Project	IEEE 802.16 Broadband Wireless Access Working Group < http://ieee802.org/16 >	
Title	The Active Multi-hop Relaying HARQ Mechanism	
Date Submitted	2007-03-05	
Source(s)	Wei Ni, Gang Shen, Shan Jin Alcatel-Lucent, Research & Innovation No. 388, Ningqiao Rd., Pudong Jinqiao, Shanghai, P. R. C	Voice: 86-21-50554550 Fax: 86-21-50554554 mailto: wei.a.ni@alcatel-sbell.com.cn
	Fang Liu, Lan Chen, Xiaoming She, Daqing Gu DoCoMo Beijing Lab 7/F, Raycom Infotech Pack Tower A No.2 Kexueyuan South Rd., Haidian District, Beijing, China	Voice: +86-10-82861501 ex.331 Fax: +86-10-82861506 mailto: {liu, gu}@docomolabs-beijing.com.cn
	Fujio Watanabe DoCoMo USA Labs 3240 Hillview Avenue, Palo Alto, CA	Voice: 650-496-4726 watanabe@docomolabs-usa.com
Re:	Response to "Call for Technical Comments and Contributions regarding IEEE Project P802.16j" (IEEE 802.16j-07_007r2)	
Abstract	This document proposes an active MR HARQ mechanism on the per-hop basis. This mechanism supports functions such as high mobility of the RS, CID update and traffic congregation. Relatively fewer resources are required for HARQ retransmissions.

The Active Multi-hop Relaying HARQ Mechanism

Figure 130ja: The active MR HARQ principle and process in the uplink

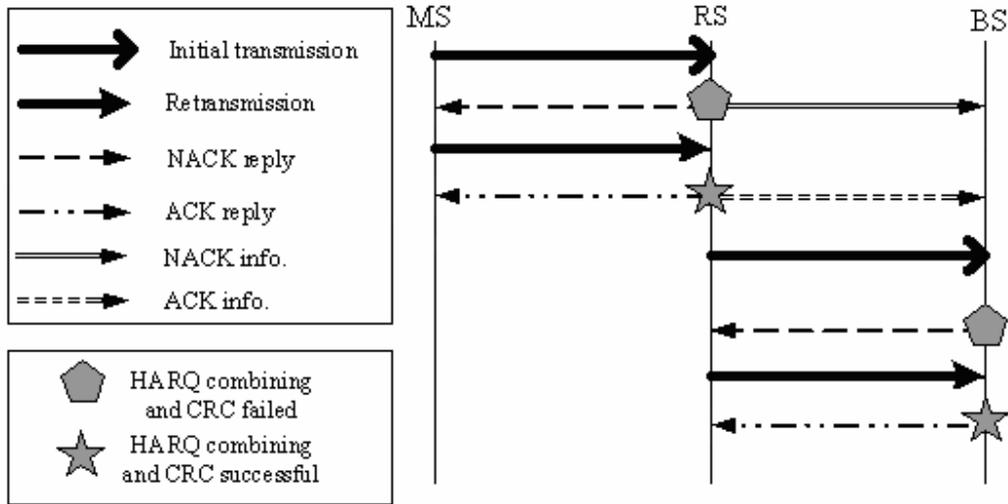
Fundamentally the active MR HARQ is a per-hop HARQ mechanism which allows for CID update and high mobility of RS. The principle and process of this mechanism is shown in Figure 130ja and 130jb. Its key feature is that besides the “ACK/NACK” reply, the intermediate RS is expected to transmit the associated “ACK/NACK information” to the BS.

In the uplink, the MS transmits its packet through a certain radio channel which is allocated by the BS and broadcasted in the previous DL-MAP. The RS receives and decodes this packet exclusively if no cooperative relay is taken into account. If the received packet passes the CRC verification after HARQ combining, the RS then replies the MS an “ACK” after a fixed delay defined by HARQ_ACK_Delay for UL burst which is

specified in DCD message (see Table 358), and meanwhile an “ACK_Info” is forwarded to the BS if there are more than two hops. Otherwise, if this packet fails in CRC verification, a “NACK” is sent to the MS within the duration defined by HARQ_ACK_Delay for UL_burst and an associated “NACK_Info” is then sent to the BS. Due to the stop-and-wait protocol, the retransmissions are only sent after receiving a NACK for the previous transmission or the ACK has not been received within the duration defined by HARQ_ACK_Delay. The similar process happens in the multi-hop links.

Figure 130jb: The active MR HARQ principle and process in the downlink

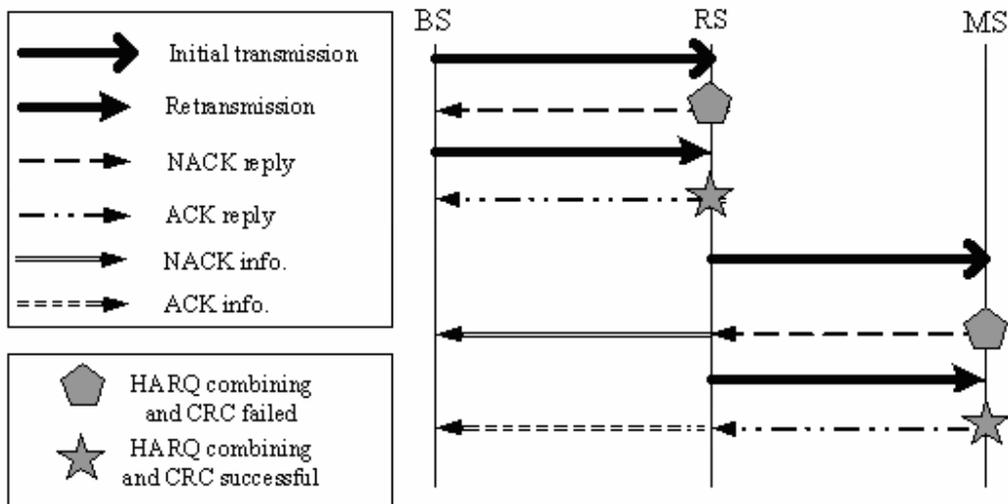
In the downlink, the process is similar to that of the uplink case except that it is the sender that transmits the HARQ_result_message (HQ_INFO) which comes from the received ACK or NACK. Therefore, the BS is kept monitoring the HARQ processes of each hop and consequently allocates the resources for HARQ retransmissions.
